SERVICE BULLETIN ATR42

Revision No. 01

This page transmits Revision No. 01 of Service Bulletin No. ATR42-57-0074.

TITLE: Wings - Outer wing box - Inspection of upper rib feet from rib24 to rib29

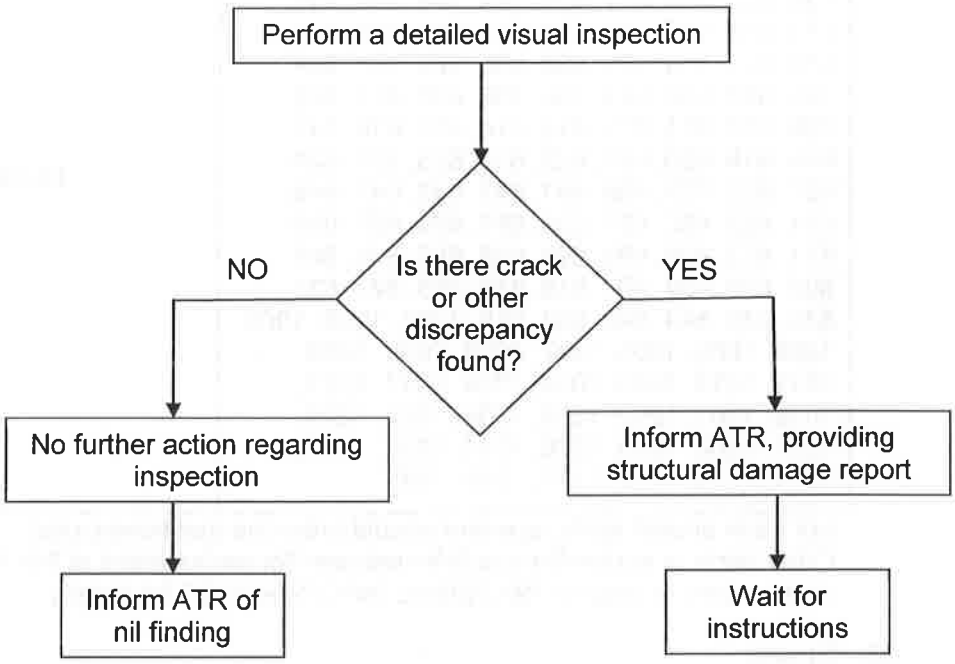
Cracks have been reported on in-service aircraft. The occurences were located at level of upper feet of the typical sheet metal ribs framing the outer wing box. These damage, if not detected and corrected, could propagate to the adjacent skin panel at rib/panel junction and could adversely affect the structural integrity of the airplane.

The aim of this Service Bulletin is to inspect these areas and to report the results to ATR.
